TECHNICAL BULLETIN

Product: Vanguard FTS 370
Date: May 26, 2021
Issued By: Ivor Lewis, Product Manager

Flash Technology is issuing this technical bulletin to notify customers, sales, technical support and service teams of the changes made to the Vanguard FTS 370 as a result of the new FAA AC 150/5345-43J.

Figure 1: Beam Profile Changes for AC 150/5345-43J compliant markers

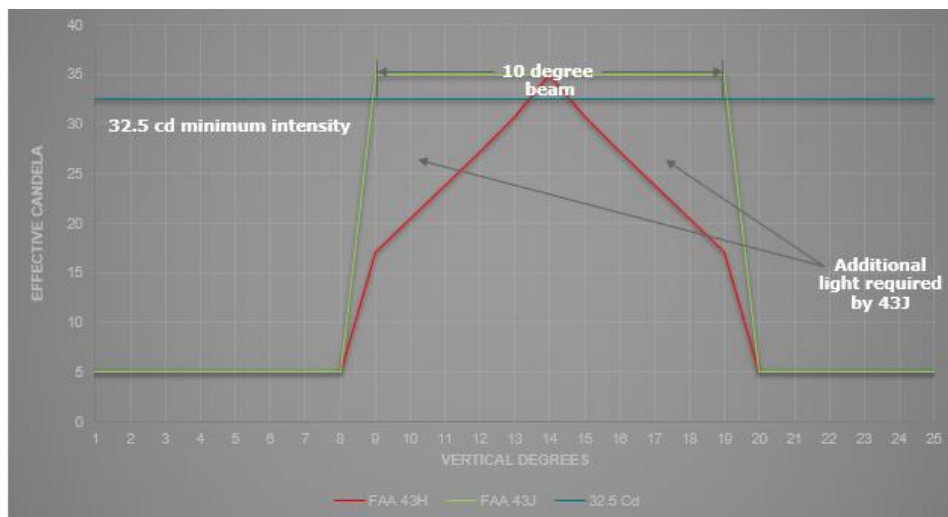
The FAA released AC 150/5345-43J which affects all towers filed after September 11, 2020. Apart from specifying the addition of IR emitters to all light sources to help visibility with NVG/NVIS, the FAA also made changes to the beam profile of L-810 markers and mandated the ability to detect 25% failure in both, the RED and the IR emitters.

Figure 2: Flashhead IR Core Board

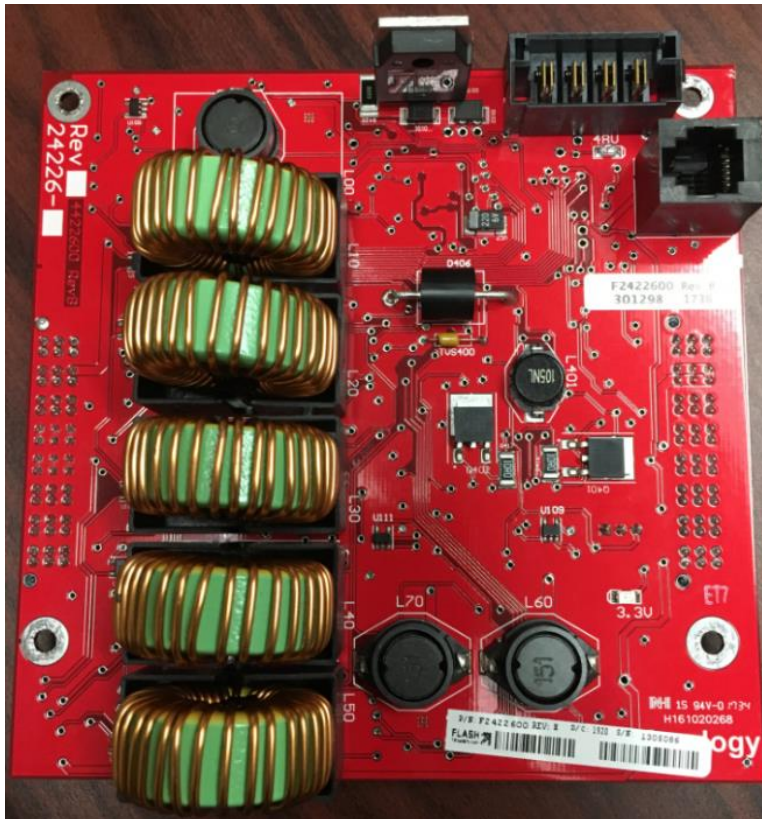
Flash Technology has redesigned the flashhead core board to support the addition of IR LED into the flashhead. The new core board is colored red to easily differentiate it from the previous version (F2422500T colored black) and all new systems are equipped with the red board.

1. When replacing core boards, always swap 'like for like'. For example, swap red board for red board or black board for black board.
2. **NEVER** replace a Red core board with a Back core board. It will damage the IR LED's in the flashhead and void the warranty.
 - a. Failure of IR LED cannot be detected by the naked eye
 - b. Failure may not be immediately apparent.
3. Do not replace a Black core board with a Red core board.
 - a. The LED strings will not be connected correctly and consequently light intensity may be lower than the FAA specified minimums.

- b. Monitoring operations will not be able to identify IR capability of the flashhead.
- c. Improper connections may result in some white LED's being activated in red night mode. This is a danger to pilots and violates the FAA directive against both red and white lights being energized at the same time.

NOTE: Only flashhead's with red core boards are in compliance with AC 150/5345-43J and AC 70/7460-1M

Figure 4: Cable Cross-Section

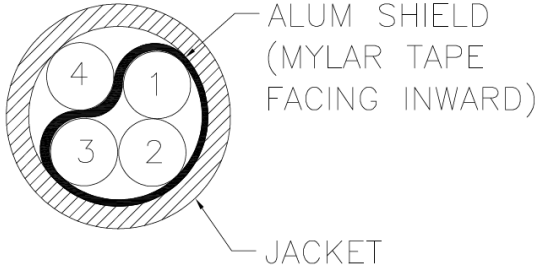
The mandate from the FAA to be able to detect a 25% failure in either RED or IR LED necessitated a change in the type of marker cable used by the FTS 370 systems.

Figure 5: F4319000 Cable TC Rated 18AWG/3C

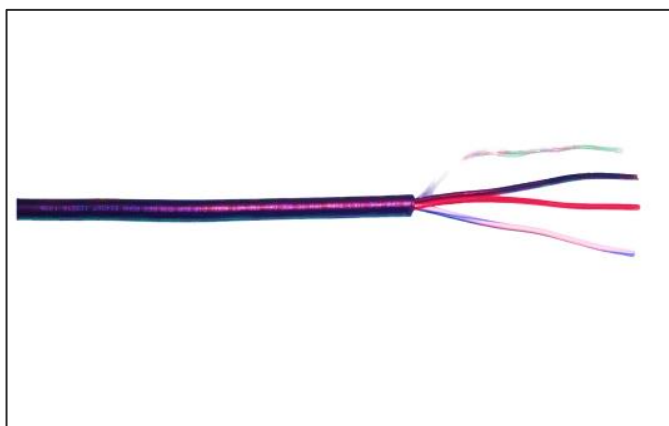
Cable F4319000 CABLE TC RATED 18AWG/3C MKR 371, is a cable containing 3 conductors and a drain wire. It replaces the previous cable (F4318000) which used 2 conductors and a drain wire. All existing kit part numbers have been updated to include the new cable.

Figure 6: Marker Interface Board (IR)

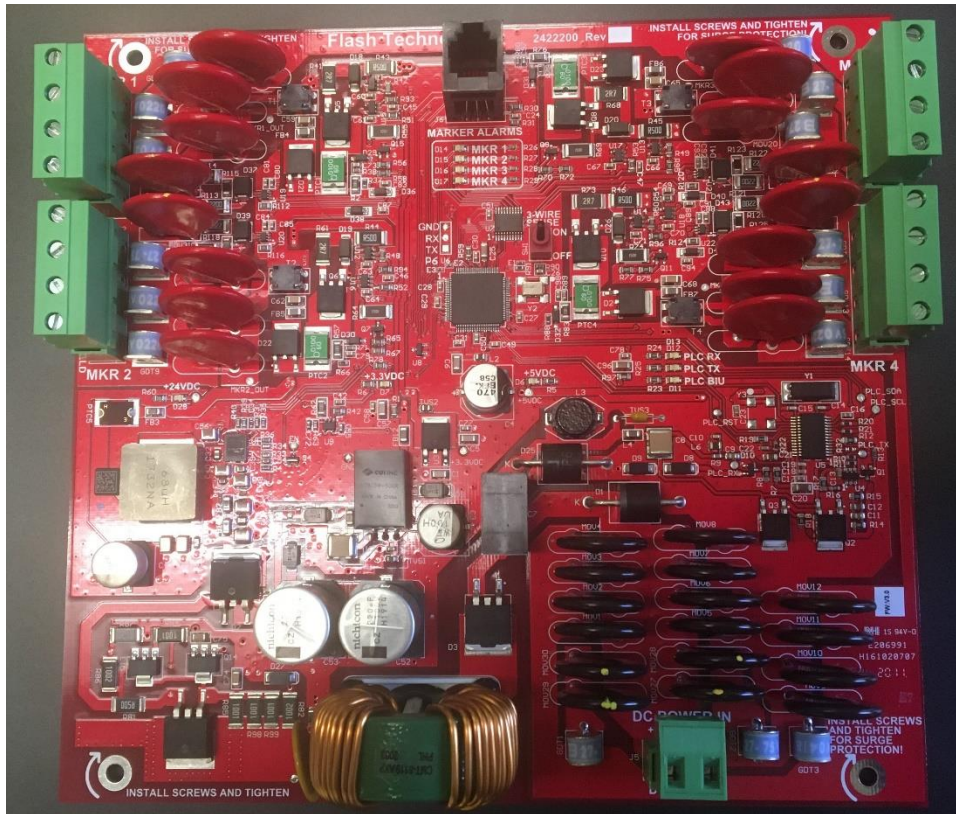
A new Marker Interface Board has been released in conjunction with the release of MKR 372. This new board replaces the previous version (F2422000T). There are several changes of note:

1. The board is colored Red to differentiate it from the old board which was Black.
2. It uses 4 pin connectors for each marker (DC+, DC-, Sense & Shield). The previous board used 3 pin connectors.
3. The board is backward compatible. It will fit into the existing Marker Interface Box and can be used with previously installed MKR 371 markers.
4. Each marker interface board is equipped with a “3-WIRE SENSE” selector switch (see figure 6 below) to enable use with either MKR 371 or MKR 372.
